Appendix B1
Greenhills to City
Centre
– 1st Non-Statutory
Public Consultation
Submission Report

Corridor 9 – Greenhills to City Centre

Emerging Preferred Route – Public Consultation Report 2018/2019

Section 1: The Square Tallaght to Cookstown Industrial Estate

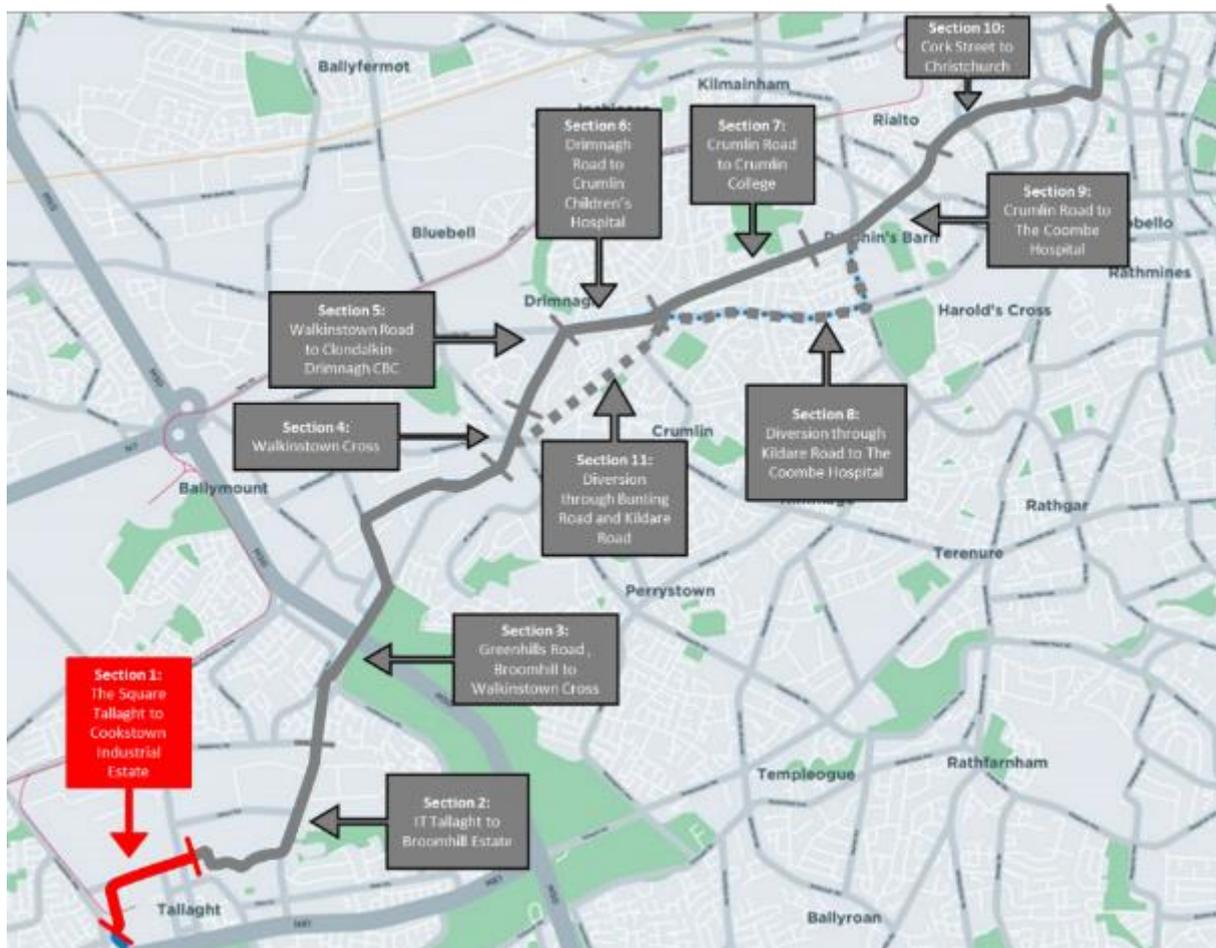
- Cycling facilities have not been provided.
- Belgard Square West is local access only, so the need for bus lanes and general traffic lanes should be examined. Reducing the vehicular carriageway to two lanes and removing the central hatching would allow space to provide segregated cycle facilities.
- Tallaght Square and Village needs to recognise the need to reduce speeds to 30 kph.
- Alterations to existing traffic management layout may cause traffic to back up through existing junctions and cause traffic congestion at this location.
- Major developments are planned within the area occupied by the Square Shopping Centre. The proposed layout along Belgard Square West will restrict access to the shopping centre.

- This area is well served by various public/ private car parks, so the provision of on-street parking should be reconsidered.
- Belgard Square North should be reviewed to provide cycle tracks; could be achieved by restricting the road to local access only, with the Tallaght bypass carrying through traffic. Alternatively make the road one-way for traffic.
- Primary Route SO5 of the Greater Dublin Area Cycle Network Plan runs along Belgard Road, so a fully protected junction for cyclists should be provided at the Belgard Road/ ITT Access Road.

Section 2: IT Tallaght to Broomhill Estate

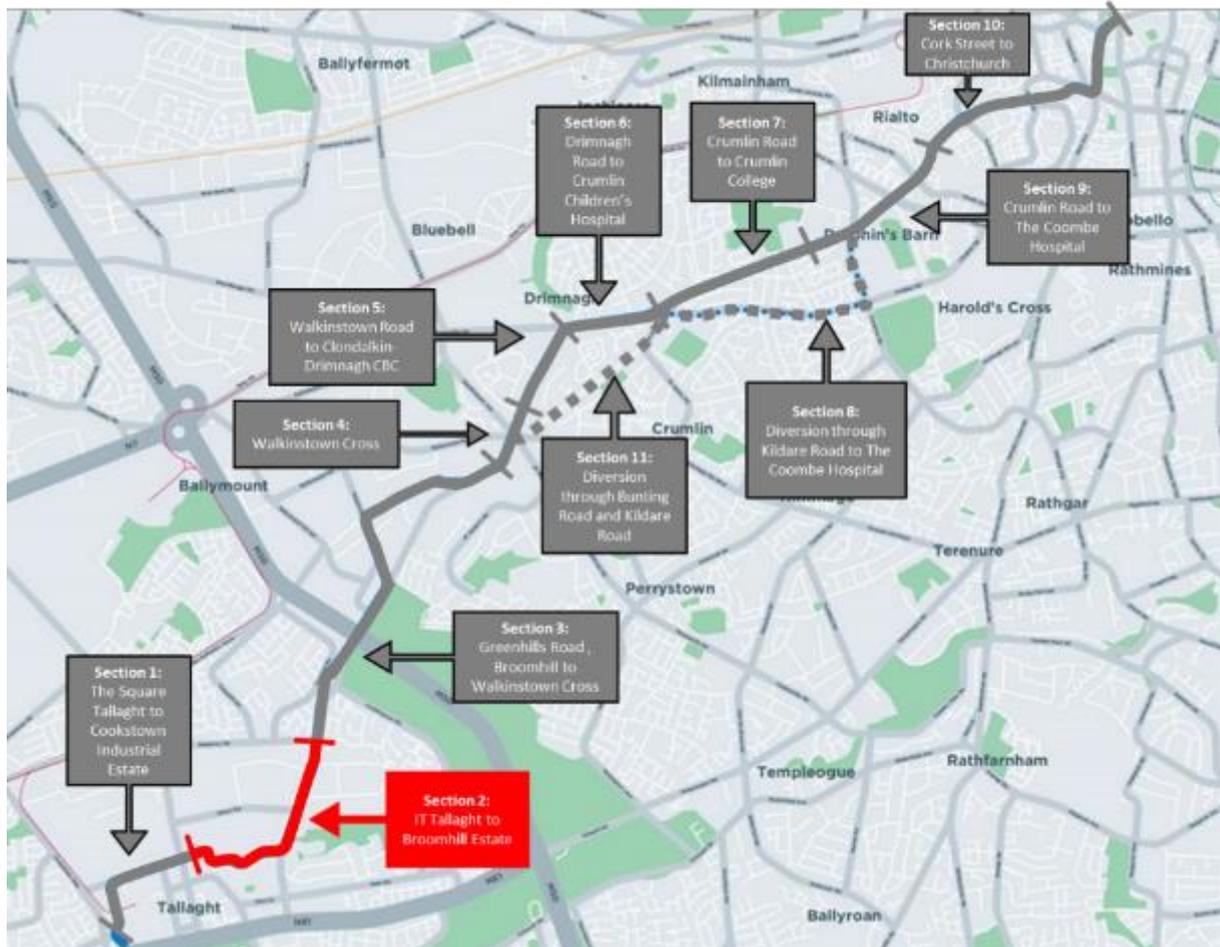
- Remove inline bus stops.
- Cyclists turning left onto Airton Road will mount the kerb.
- Junctions should be raised and a buffer space should be provided between the road/ cycle track, to remove cyclists out of HGV blind spots.

- Shared space unacceptable at Broomhill Road Junction.
- Cyclists turning left onto Mayberry Road will mount the kerb.
- Junctions should be raised and a buffer space provided between the road/ cycle track, to remove cyclists out of HGV blind spots.
- Suggestion to close one of the two entrances to Hibernian Industrial Estate to improve the overall safety of cyclists and pedestrians and reduce potential conflicts.
- Safety of and provision for right turning cyclists both into/out of Mayberry Road needs to be factored into the design.

Section 3: Greenhills Road, Broomhill to Walkinstown Cross

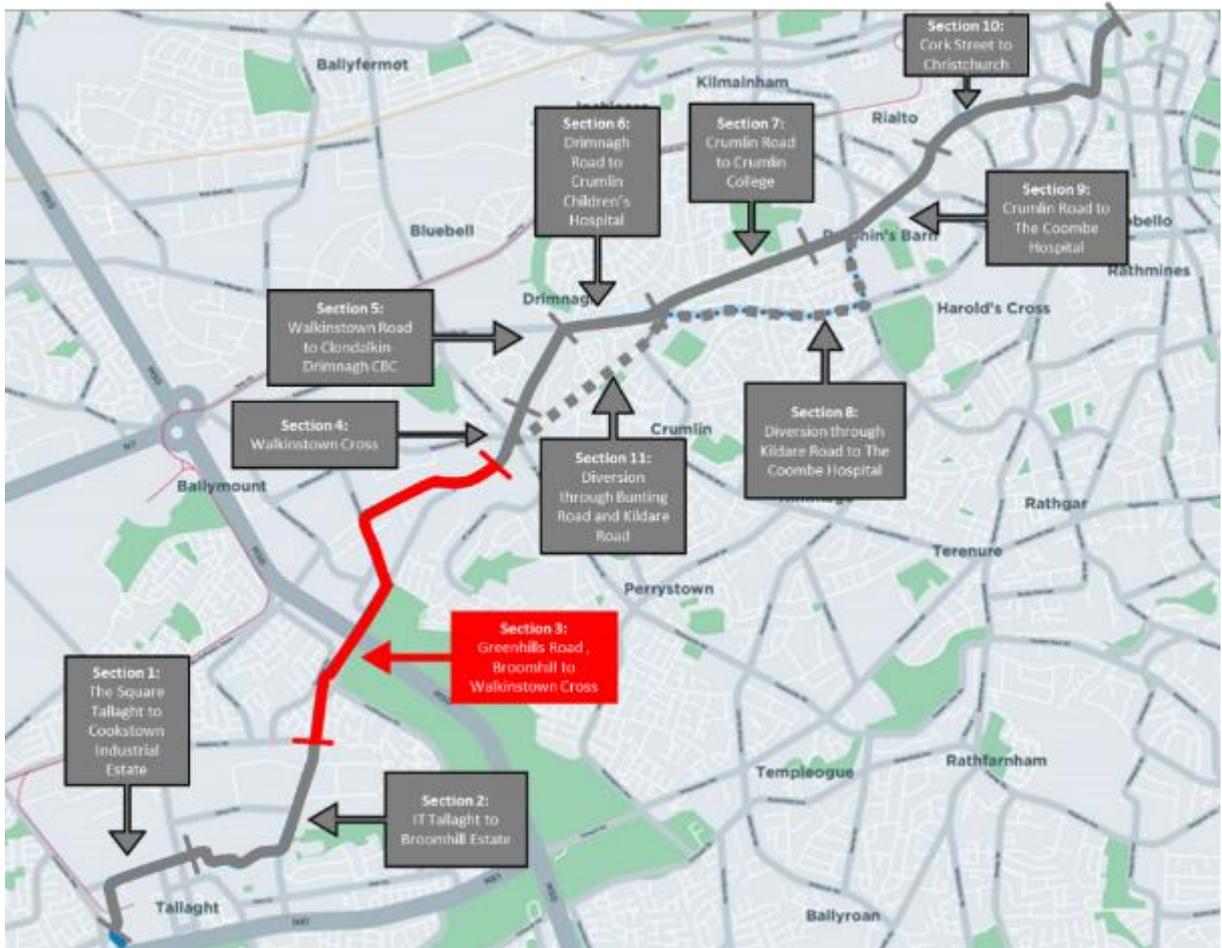
- Unacceptable inline bus stops.
- All four arms of the Calmount Road/ Ballymount Avenue junction are Secondary Routes (7E and 8A) of the Greater Dublin Area Cycle Network Plan, so a Dutch Style Junction should be considered.

- All six corners of this roundabout are currently used as car parking. Land take from these could provide a Dutch Style junction.

- If cycle facilities at all arms is not feasible, at least provide a bidirectional cycle track connecting Greenhills Road to Bunting Road.
- The junction between Bunting Road and Cromwellsfort Road is not at all safe for cyclists. The outbound cycle track suddenly disappears just before the junction. Inbound cyclists also inexplicably lose their cycle track at the bend. It is not clear how an outbound cyclist on Bunting Road can re-join cycle tracks on Greenhills Road, nor how they will make a right turn.

- Suggestion that a signalised junction would be a better option instead of the roundabout.
- Residents of Greenhills Road have concerns regarding the pedestrian crossing just before Walkinstown Cross Roundabout. Drivers often break the red light; traffic calming measures should be implemented.

- Queries regarding the two existing electric vehicle charging points at the roundabout, will they be maintained?

Section 5: Walkinstown Road to Clondalkin-Drimnagh CBC

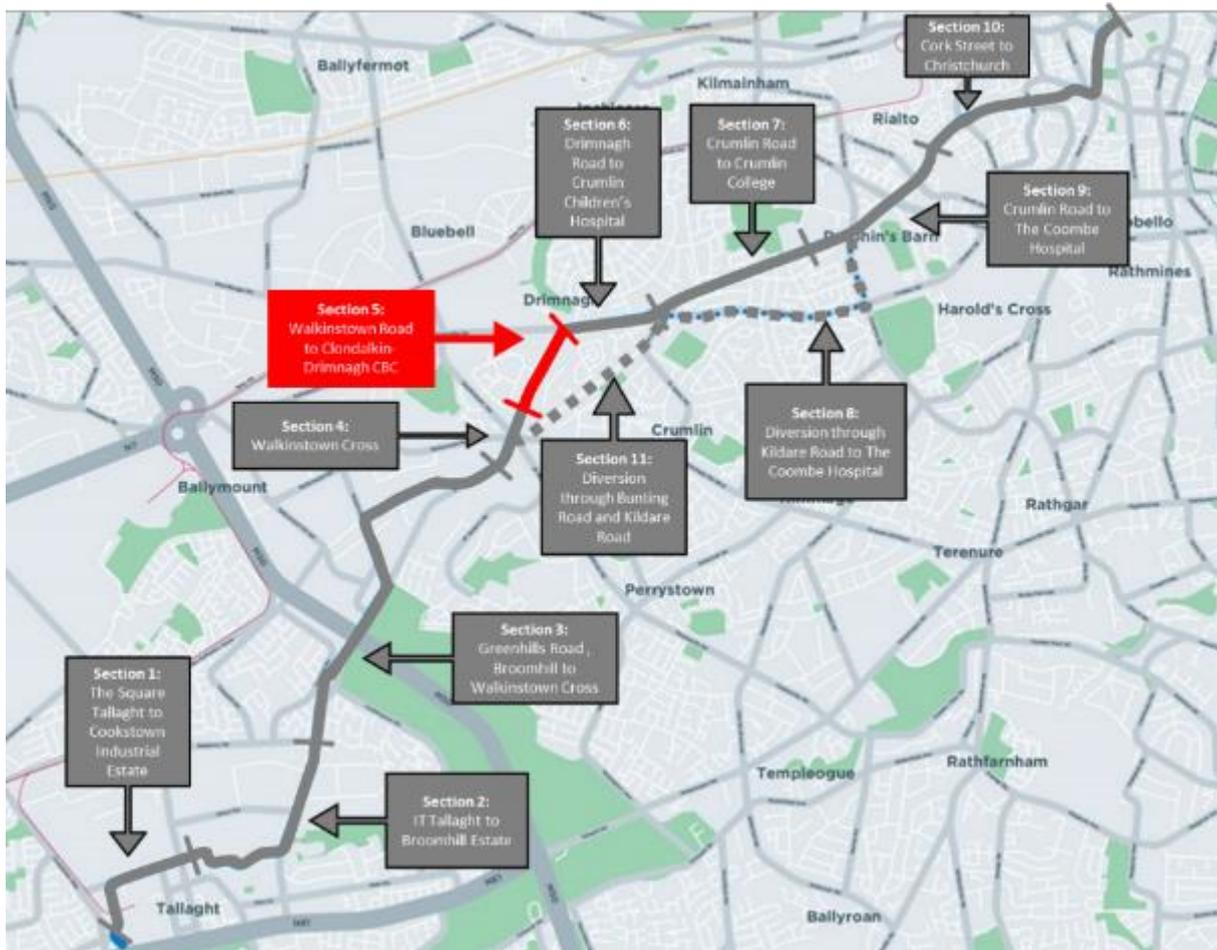
- Vital that direct and safe access is provided during the construction phase from residences onto Walkinstown Road.

- The addition of two “no-right turn” signs at Kilnamanagh Road will encourage a rat run through the SuperValu car park in order to gain access to Kilnamanagh Church, Assumption Secondary School and Assumption Primary School from Walkinstown Road. This will impose a serious issue during the AM Peak.
- Confusion with land take here. Road width shows 4 lanes yet only 2 lanes at present.
- Left turning cyclists from Long Mile Road onto Walkinstown Road are forced to share road with buses and vehicles.
- Removal of pedestrian island at Long Mile Road junction is a safety concern.
- Footpath outside of bank on Map 20 has been greatly extended which may make bus turning difficult from the Drimnagh Road onto Walkinstown Road.

Section 6: Drimnagh Road to Crumlin Children's Hospital

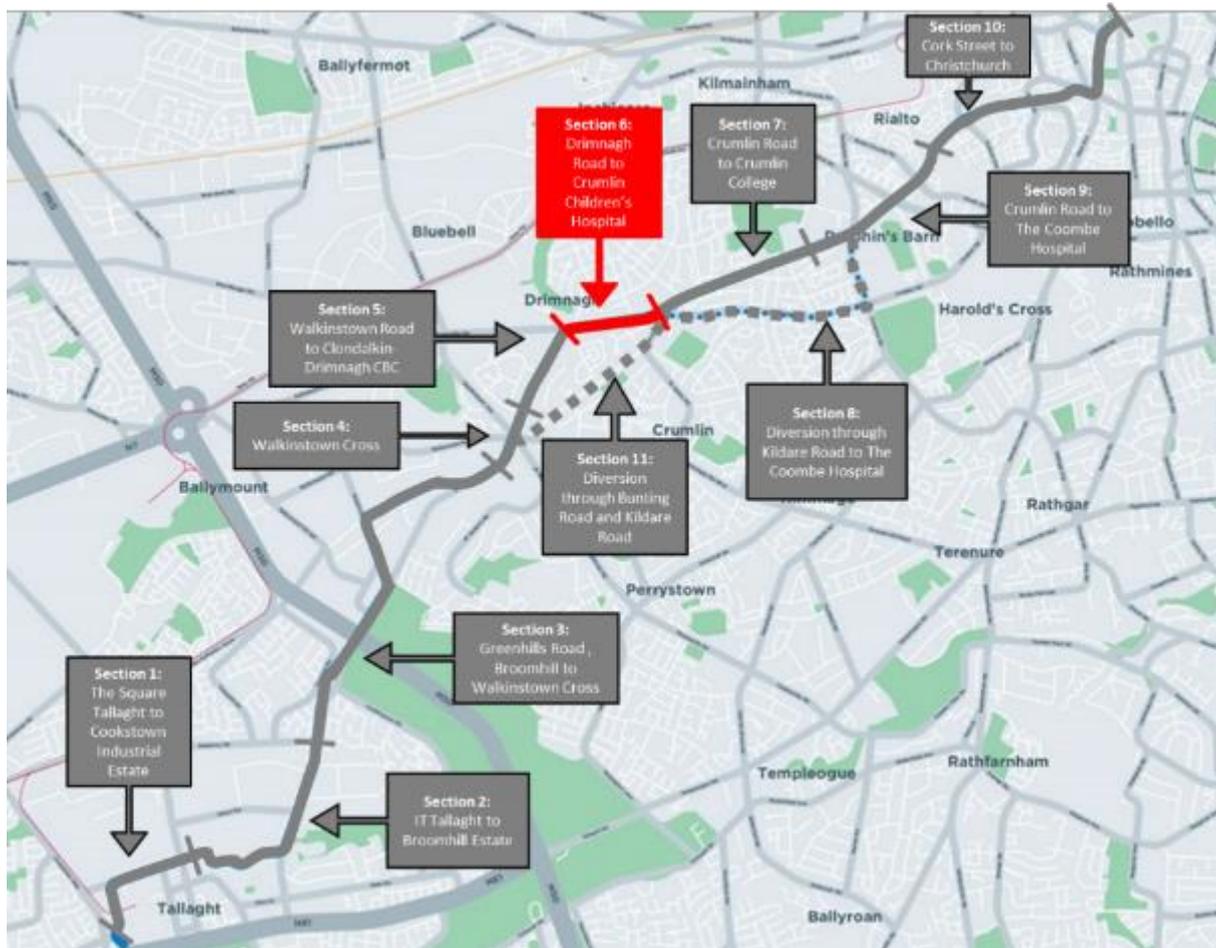
- Cycle lanes should be marked going through junctions to prevent accidents.
- No cycle lane on Crumlin Road.
- No pedestrian crossing at Kildare Road.
- Diversion routes are too narrow and not suitable for van access.
- The proposed plan will make it difficult for a cyclist to travel westbound from the Crumlin Road to the Drimnagh Road at the junction.
- Suggestion that land take should be taken from Crumlin Children's Hospital due to the construction of the proposed new children's hospital.

Section 7: Crumlin Road to Crumlin College

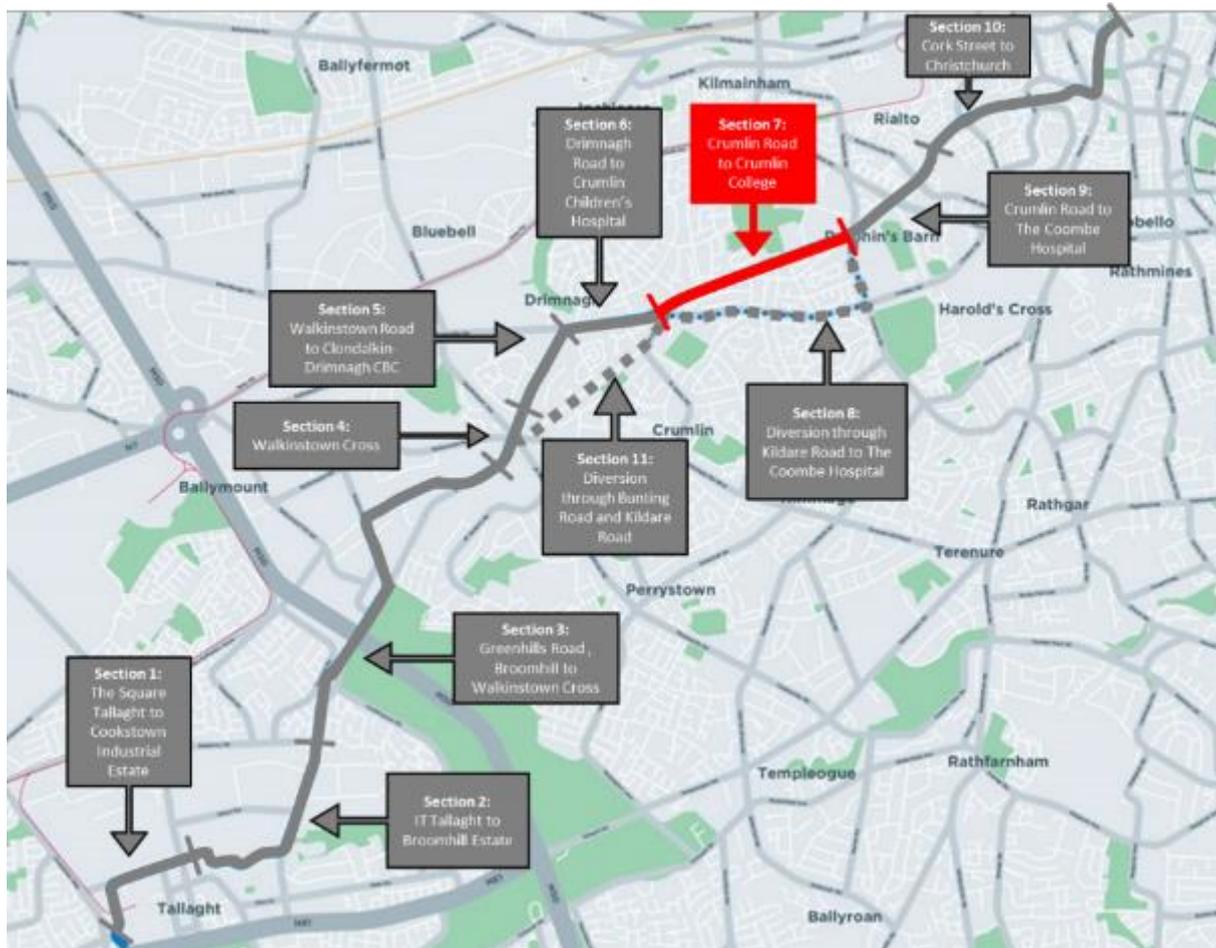
- Reduction of privacy along Crumlin Road. Current planning regulations provide minimum offsets of windows to prevent overlooking by neighbouring properties, but this issue seems to be ignored as the public footpath will be closer to ground floor windows, and buses passing every few minutes will be closer to 1st floor windows.

- Large amount of green space and planting along Crumlin Road is proposed to be removed.
- Removal of dedicated cycle lanes and the proposal to integrate these into shared use of bus lanes for cyclists seems counter intuitive. No local access for children and youths to school, swimming pool, GAA club etc.

- More trees should be planted to enhance environment. Mimic roads such as Griffith Avenue.
- Combined total of 288 buses in a 12 hour period (24 buses per hour from routes 27, 77a and 151) will bring air pollution, noise pollution, and street lighting issues close to residential windows and potentially natural drainage issues.

- The outbound bus stop at Crumlin Road/ Windmill Road junction (Iveagh Gardens) has been removed. There is no shortage of space at this location and it would be an opportunity to provide a bus bay and dedicated parking for local shops and businesses.

- Residences 181 to 197 have land take proposed on Map 25; this is a serious issue as these houses have no other parking spaces.
- Resident requests a wrought iron rail on top of their new boundary wall, a single hinged gate to replace the current gate and a new rubbish bin.

- Parking around the shops on Crumlin Road belongs to the sports ground behind it; removal of this parking would cause havoc for players and supporters.

- Residents would prefer to not have shelters at bus stops along Crumlin Road as they lead to antisocial behaviour.
- Parking required for staff at Crumlin College (9-10 cars).

Section 8: Diversion through Kildare Road and Sundrive Road

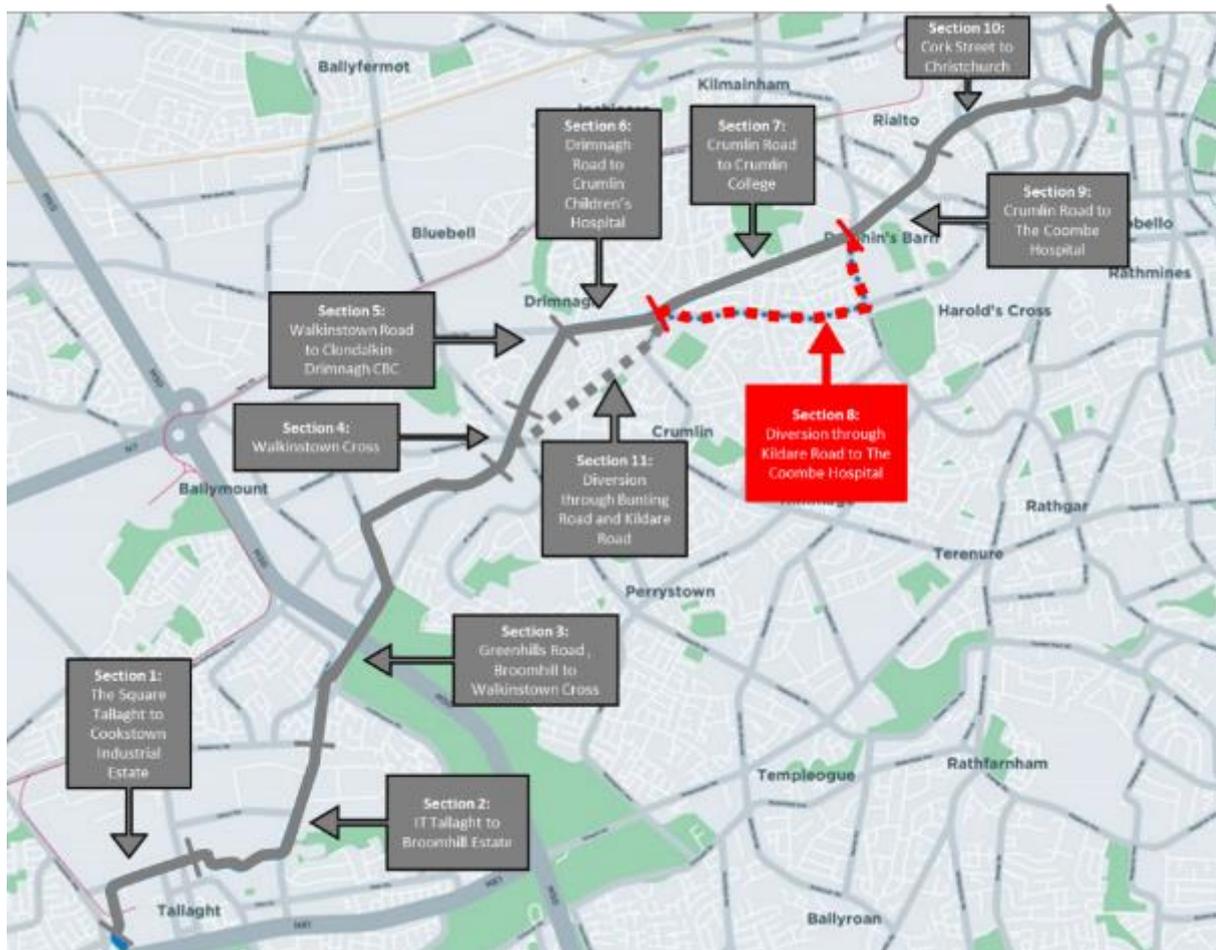
- The cross-section of Kildare Road is approx. 15 – 17.6m wide, which is relatively wide for a residential street. It may not be necessary to provide cycle tracks on all sections of Kildare Road however; there is space for dedicated cycle facilities while maintaining on-street car parking.

- The use of Slane Road as a cycle route is questionable due to conflict with local traffic on a narrow street.
- Dangerous right turn for cyclists from Slane Road onto Clogher Road.
- Continue cycle lane through Clogher Road to join up the Canal Way Cycle Route or continue along Donore Avenue to South Circular Road or perhaps Cork Street.
- Suggestion to make Clogher Road one way.

- Dangerous right turn for cyclists from Sundrive Road onto Downpatrick Road.
- Shared space at the corner of Downpatrick Road is dangerous and leads straight into an inline bus stop.
